MILITARY SPECIFICATION

CONVEYORS, ROLLER AND WHEEL, GRAVITY AND CONVEYOR SUPPORTS

This amendment forms a part of Military Specification MIL-C-11218D, dated 28 May, 1974, and is approved for use by all Departments and Agencies of the Department of Defense.

FIGURE 1. Hook & rod coupler.

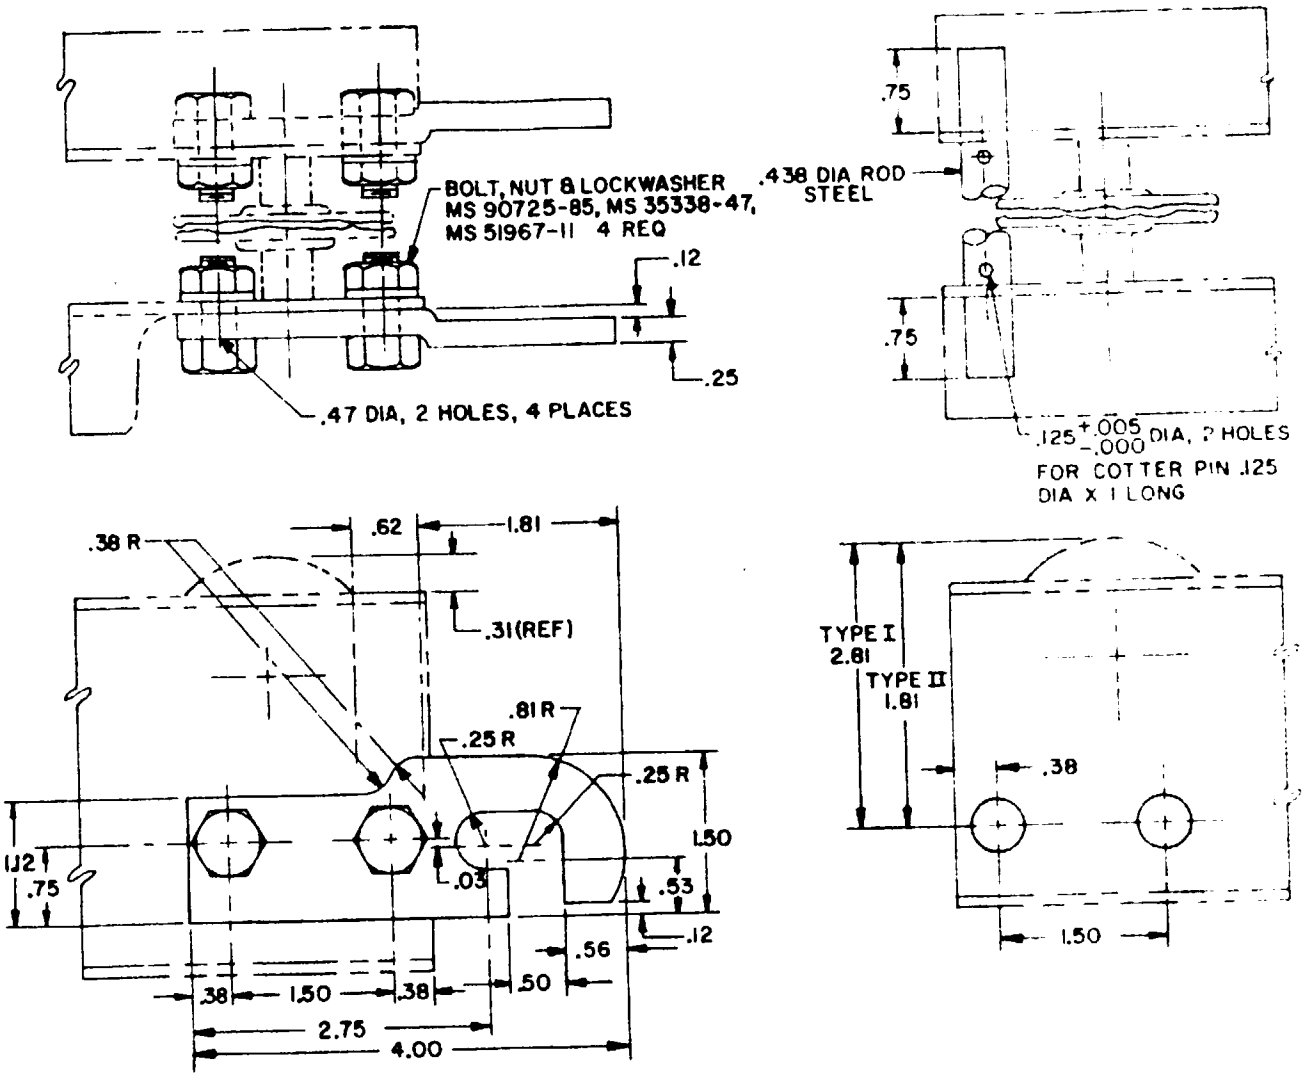
Delete Figure 1 (X-2351A) and substitute new Figure 1 dated 27 February 1975.
